Document ID 1515435	Version 1.0	Status Approved	Reg no	Page 1 (11)
Author Jan Hernelind/5T Engineering AB			Date 2015-10-21	
Reviewed by Mikael Jonsson Christina Lilja Jan Sarnet			Reviewed date 2015-10-28 2015-10-28 2015-10-28	
Approved by Helene Åhsberg			Approved date 2015-10-28

Answers to SSM questions 2015-10-12

SSM has asked questions regarding creep results for (SKBdoc 1419643 ver 1.0) and (SKBdoc 1399768 ver 2.0) which are answered below.

Figure 3-1. Established contact for load case 2 in (SKBdoc 1419643).

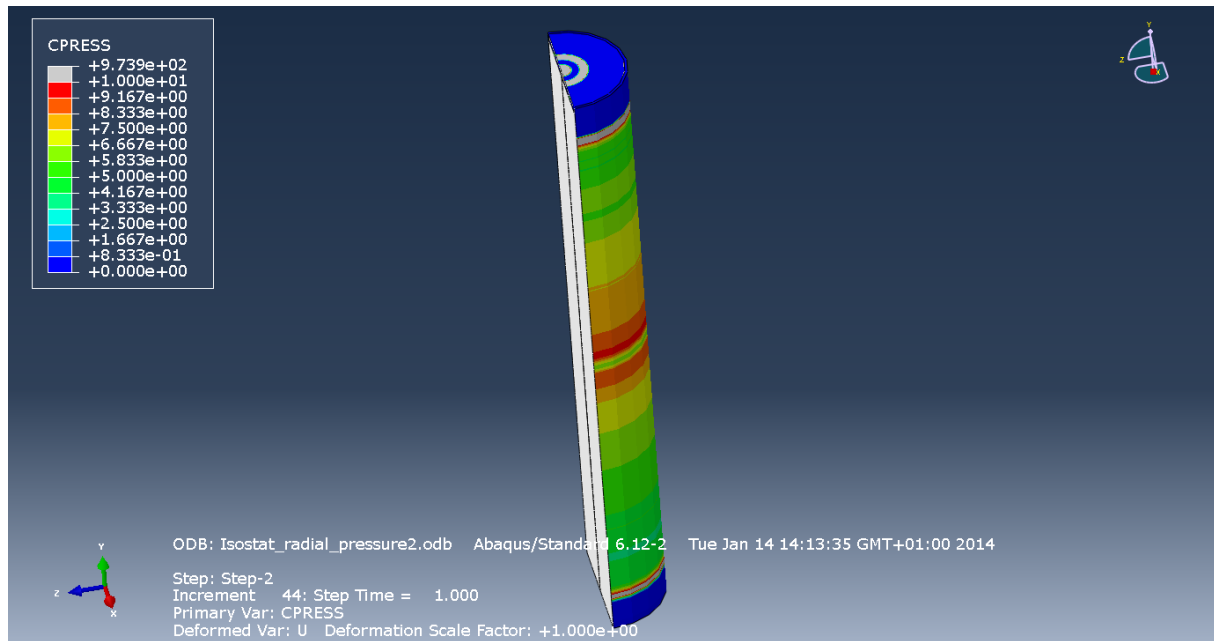
8. Is the copper cylinder in contact with the insert when the shear stress and the swelling pressure are applied on the copper cylinder in the second load case? If not, 1) what is the initial gap between the copper cylinder and the insert and 2) is the gap closed during the analysis?

The initial gap between the copper shell and the insert is 1.56 mm. For the first load case contact is not established, but for load case 2 contact is established partly, see Figure 3-1 in the present report below.

Figure 4-1. Correct layout of Figure 4-3 in (SKBdoc 1399768).

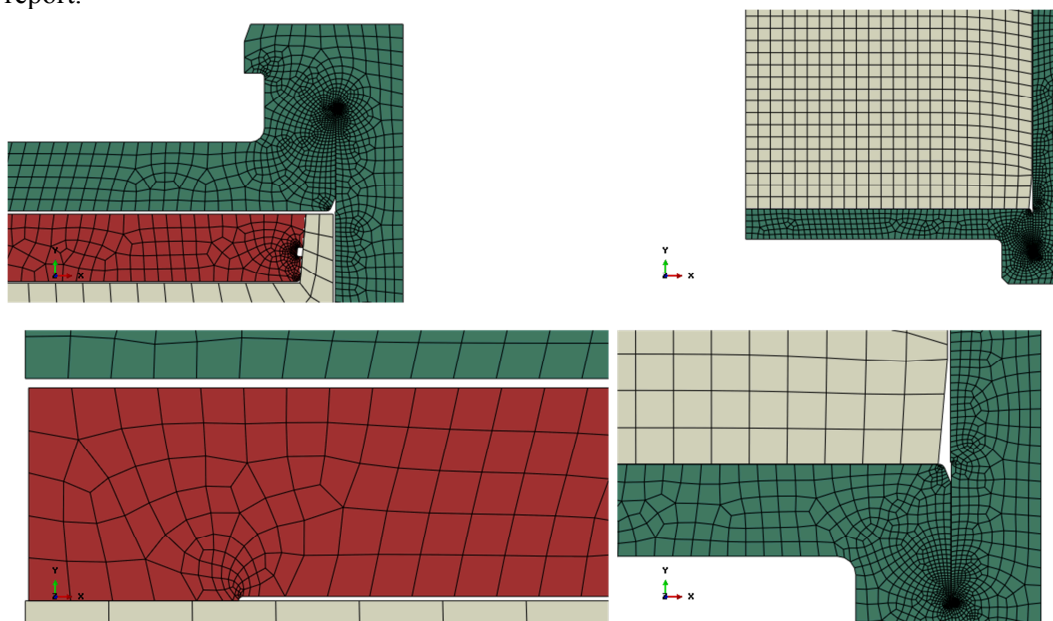
4. In figure 4-2 and 4-3, the insert is placed up-side-down with respect to the copper canister. Is the model shown in the figures used in the analyses?

The plots in Figure 4-3 are wrong. Figure 4-3 should be as below in Figure 4-1 below in the present report.

Figure 4-2. Contour plot of minimum principal stress for creep2_red_dim.

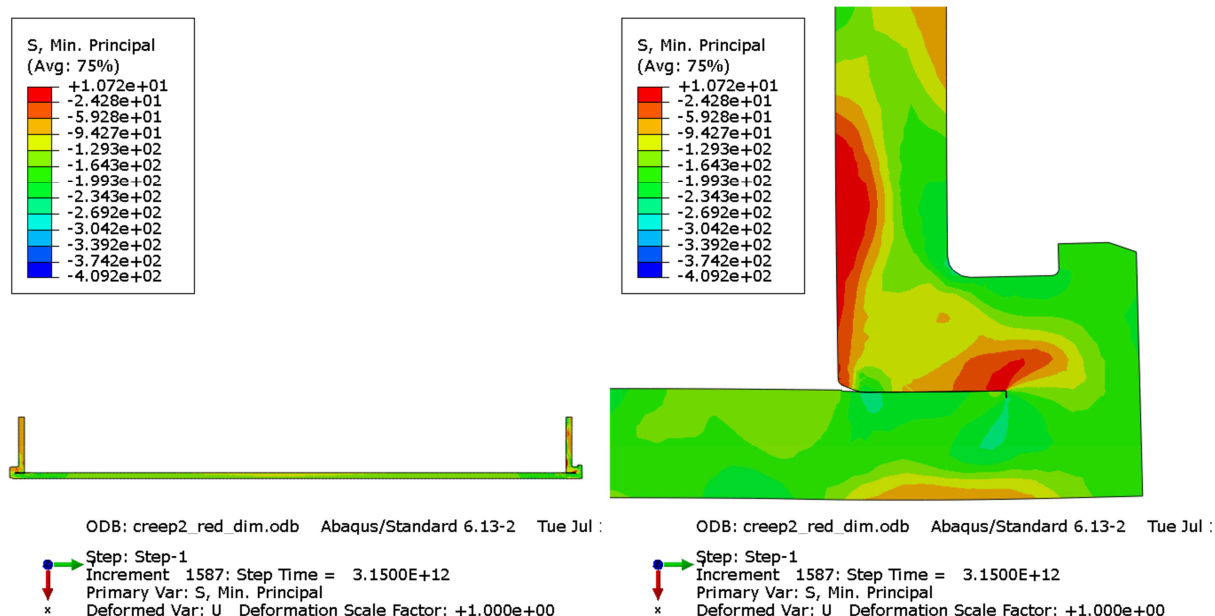
5. Figure 10-2 and figure 10-3 are difficult to compare as they show results from different analyses, i.e. isostat_JLH_creep_red_dim and isostat_JLH_creep_blue_dim. Is it a mistake that results from the latter analysis is shown in figure 10-3? Is a contour plot of minimum principal stress available from the analysis isostat_JLH_creep_red_dim?

The wrong figure was included in Figure 10-3. It should contain results for creep2_red_dim, see Figure 4-2 below in the present report.

Figure 4-3. Plot of CEEQ just before 20 000 years (left plot) and at 100 000 years (right plot).

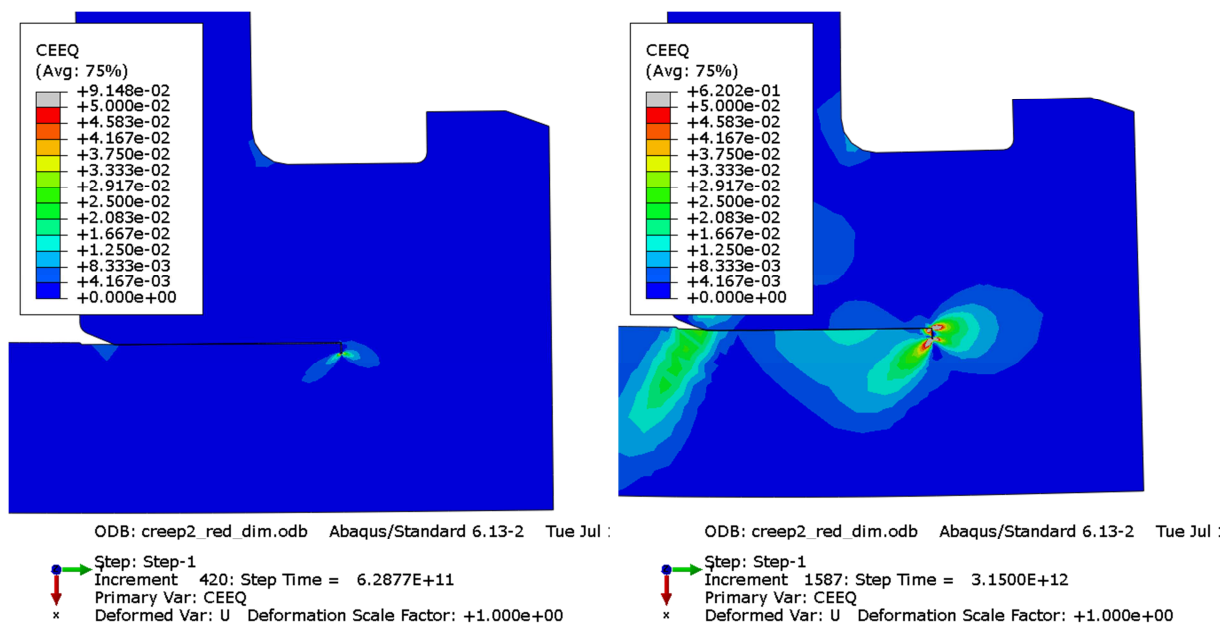
8. Creep strain development over time is shown in specific elements, see for example figure 10-16. This gives an idea of local effects. Regarding global effects it would be of interest to compare creep strain development just before the onset of the glacial period at time 20000 years with that at time 10^5 years. Are contour plots of CEEQ at time 20000 years available for comparison with results presented in the report? If yes, the same scale as for the contours plots at 10^5 years is preferred.

See Figure 4-3 below in the present report, plot of CEEQ just before 20 000 years (left plot) and at 100 000 years (right plot).
